# UNITED STATES PATENT AND TRADEMARK OFFICE

APPLICATION NO.	FILING DATE	FIRST NAMED INVENTOR	ATTORNEY DOCKET NO.	CONFIRMATION NO.
10/784,422	02/23/2004	Haruki Hiranuma	S004-5217	2563
7590 12/21/2005				
ADAMS & WILKS 31st Floor 50 Broadway New York, NY 10004			EXAMINER KAYES, SEAN PHILLIP	
			ART UNIT 2841	PAPER NUMBER

# Office Action Summary

II.

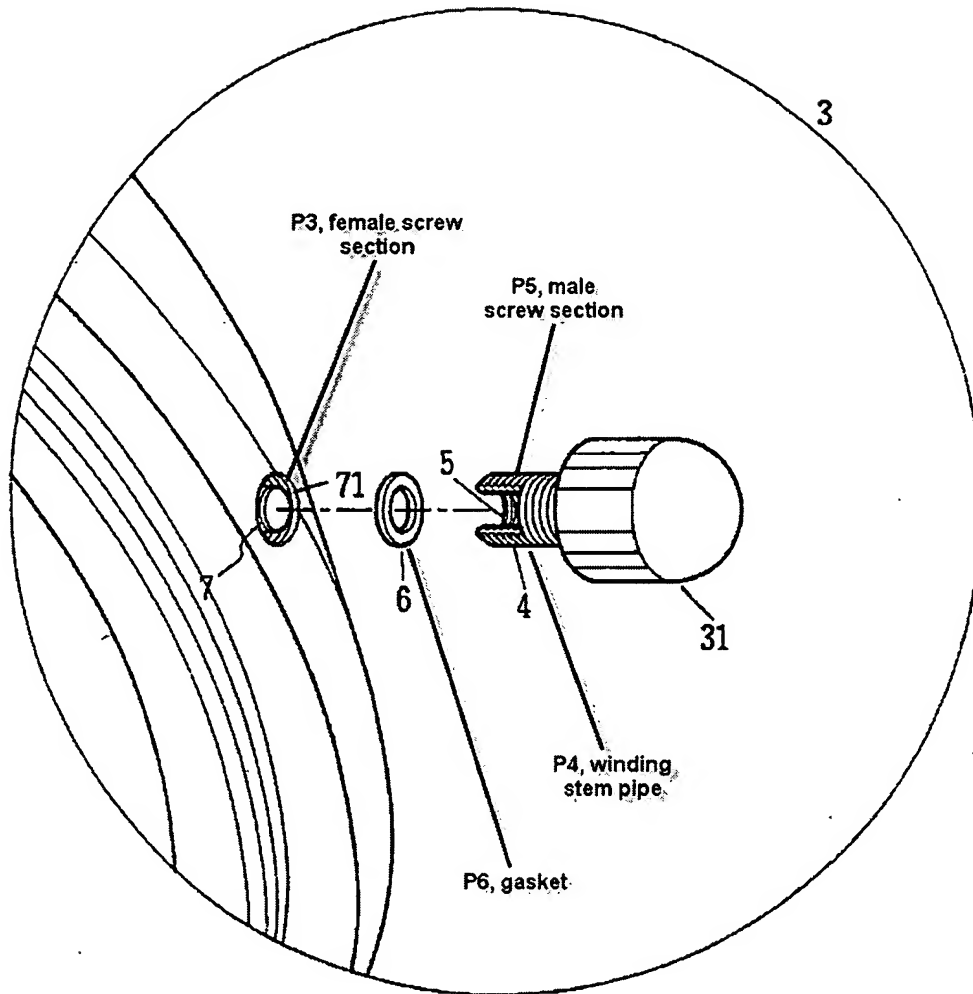
4. Claims 1-6 are rejected under 35 U.S.C. 103(a) as being unpatentable over Li (US 5598383) in view of Sechler (US 2002/0033069, note this publication was later patented with patent number US 6581494.)
5. With respect to claim 1 Li discloses a portable watch (column 1 lines 6-13), comprising: a case band (P2, picture I.) provided with a pipe-attachment hole (P1) including a female screw section (P3, figure II.); a winding stem pipe (P4) attached to the case band after going through the pipe-attachment hole, including a first male screw section (P5) to be screwed together with the female screw section (P3) in a removable manner, a waterproof gasket (P16) sandwiched between the case band and the winding stem pipe. Li does not disclose the all male reverse thread design and a clamp ring separate from the stem pipe.

## III.

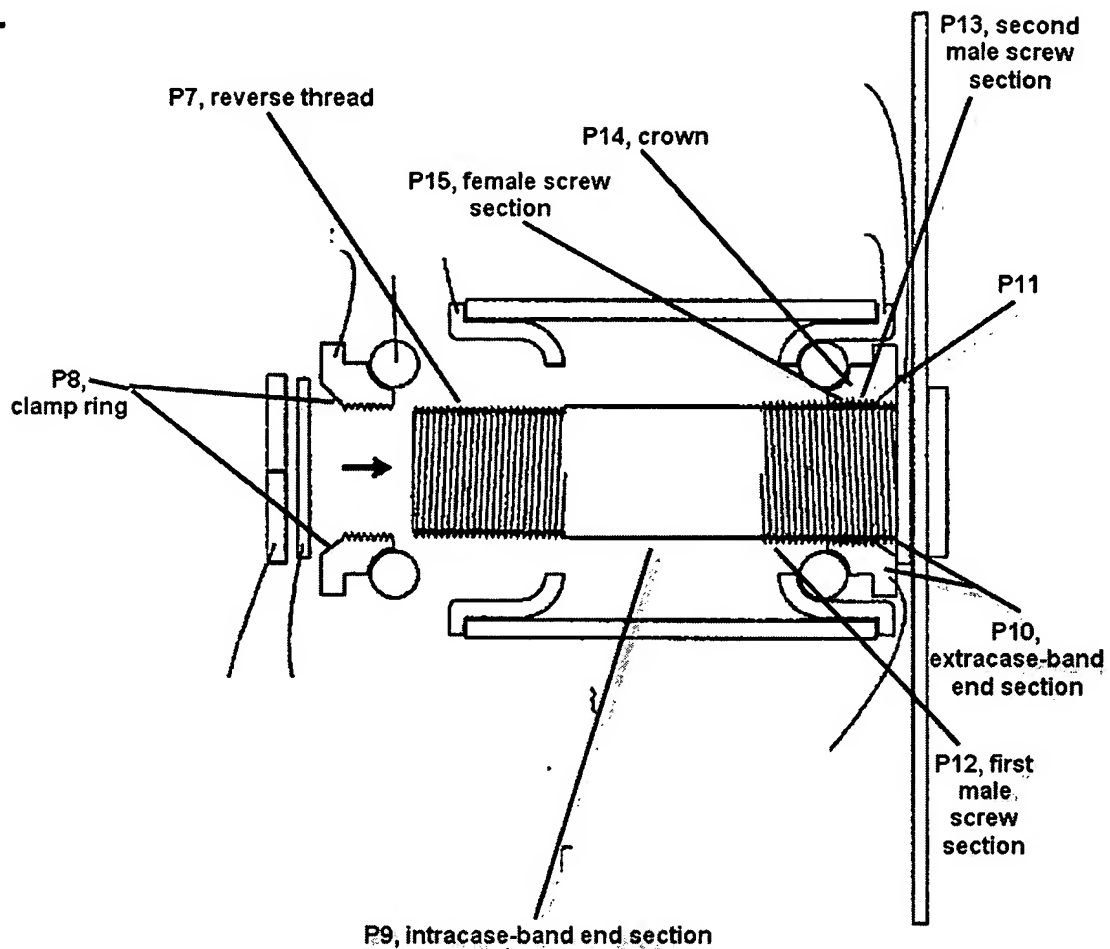
Sechler discloses an intracase-band end section (P9, picture III.) provided with a screw section being a reverse screw (P7) for the first male screw section (P12), and an extracase-band end section (P10) including a second male screw section (P13) and abutting to an outer surface of the case band (P11); a clamp ring (P8) screwed together with the screw section of the intracase-band end (P9) section in a removable manner, sandwiching the case band with the extracase-band end section (P10); and a crown (P14) including a crown main section formed with a female screw section (P15) to be screwed together with the second male screw section (P13) in a removable manner.

## IV.

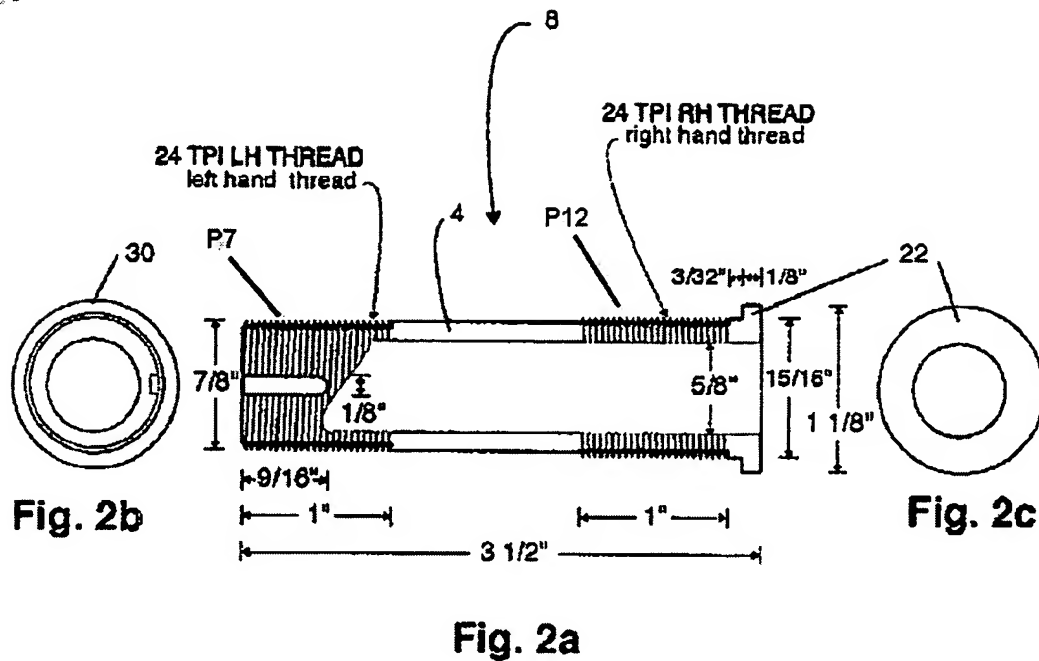
Sechler discloses wherein an outer diameter of the screw section (P7) of the intracase-band end section is formed to be smaller than an outer diameter of the first male screw section (P12; see figure 2 a version of which is provided below in the form of picture IV.)

At the time of the invention it would have been obvious to one skilled in the art to combine Sechler's thread design with Li's watch to facilitate a more stable water resistant seal.

The suggestion motivation for using the thinner inner thread is so that the whole apparatus can be inserted into a fitting such that the reverse thread of P7 will not have to be compatible with the female thread designed to fit P12.
